UNITED STATES PATENT AND TRADEMARK OFFICE

10/539,686

Office Action Summary	Application No. 10/539,686	Applicant(s) KINGSFORD ET AL.	
	Examiner Matt Benvenuti	Art Unit 4159

DETAILED ACTION

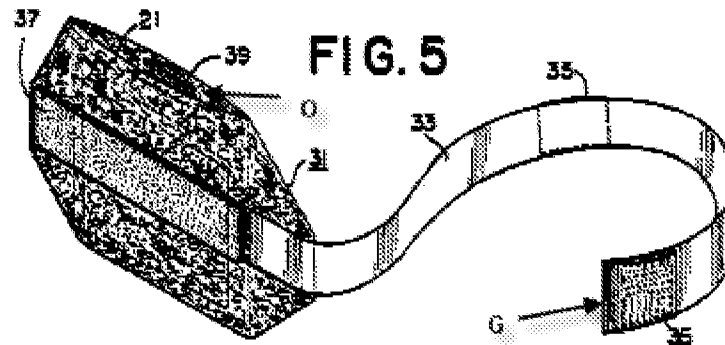
10. In re Claim 1, Anderson, Figure 5 shown above, teaches a bag comprising:

- A bag body (31) defining therein a compartment (27) accessible through an opening at one end of the bag body (31); and
- Secured to the bag body (31) along one edge thereof and extending therefrom to a free distal end, a flexible strap (33), the strap (33) carrying an array of fastener elements (35) on an opposite side thereof (Column 3, Lines 38-43)
- The strap (33) being of sufficient length to wrap about an object, with the strap (33) overlapping the bag body (31) to engage exposed fibers (37) of the bag (31) with the fastener elements (35), to secure the bag (31) to the object. (Figures 5 and 6)

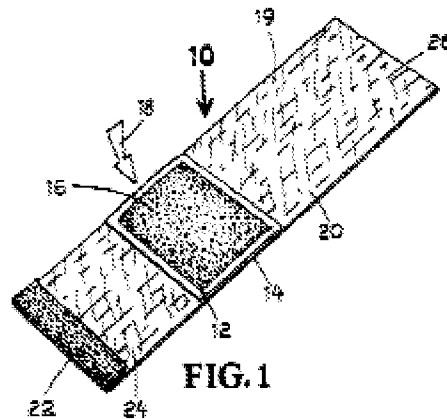
12. Shesol et al, Figure 1 shown above, teaches a wrap (20) having the same width as the carrier platform (12), which can include a pocket (28 in Figure 4). Shesol et al shows that a strap of width equal to the bag body is an equivalent structure **known in the art**. Therefore, because these two straps were art-recognized equivalents at the time the invention was made, one of ordinary **skill in the art** would have found it obvious to substitute a strap of equal width as taught by Shesol et al for the strap of smaller width in Anderson.

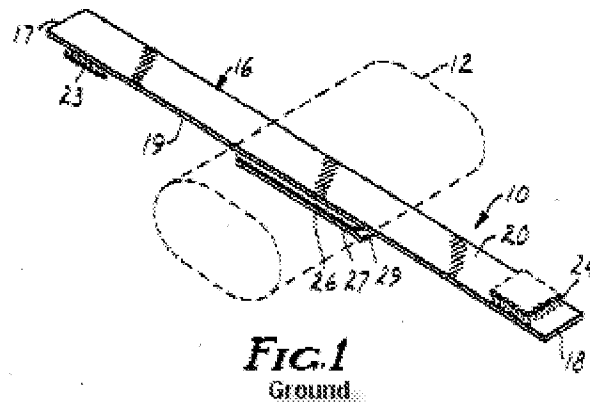
32. In re Claim 19, Anderson/Shesol et al/Shepard et al does not teach a method of releasably securing one or more relatively small components to a relatively larger object, wherein the relatively large object is a chassis, and the components are to be later assembled to the chassis. Ground, Figure 1 shown above, teaches an attaching assembly for holding wires to a structure such as a firewall of an automobile. It would have been obvious to one of ordinary skill in the art at the time the invention was made to attach the bag of Anderson/Shesol et al/Shepard et al to an automobile structure, such as a chassis or firewall, as taught by Ground, and place within the pouch
